SERVICE BULLETIN NUMBER SB 131
ISSUE 1 **PAGE 1 of 3**

TITLE	Fuel System, Rohacell dimpling and fuel leaks.
CLASSIFICATION	The CAA have classified this bulletin as Mandatory
COMPLIANCE	Read and ammend operations as directed, append to manual.
APPLICABILITY	All UK registered CT2K and CTSW aircraft.

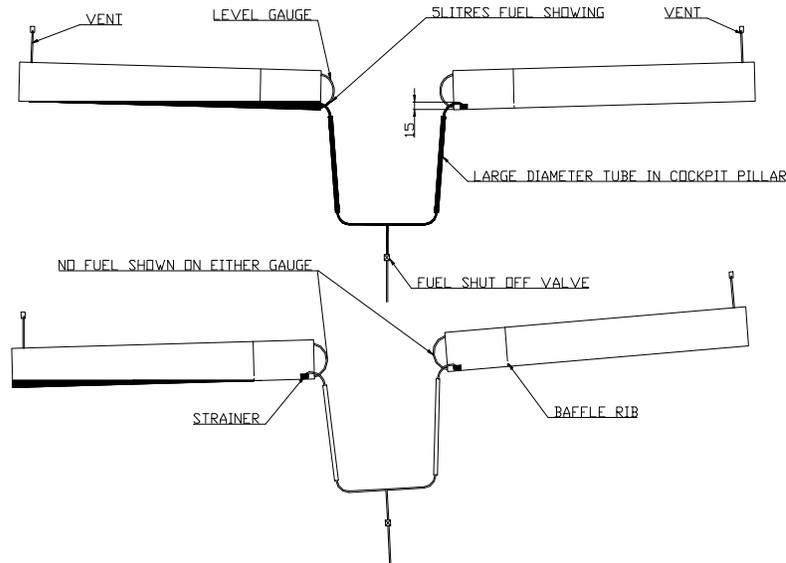
A CTSW ran out of fuel when apparently 5 litres remained in one tank and no fuel indicated in the other. 5 L is marked in red on each level gauge and is the minimum that can be measured. The aircraft has integral tanks, one in each leading edge. There is a baffle rib near the wing root end of each tank. The tank pickups have coarse mesh strainers and a feed pipe with a goose neck 15mm high. The tanks are interconnected on all CTSW and also on the CT2K with modification M186. The tanks are vented by individual vents at the outboard end of each tank. See fig 1 below.

If one tank should empty before the other, in level flight the remaining fuel can still be used up as shown in the top view of fig 1.
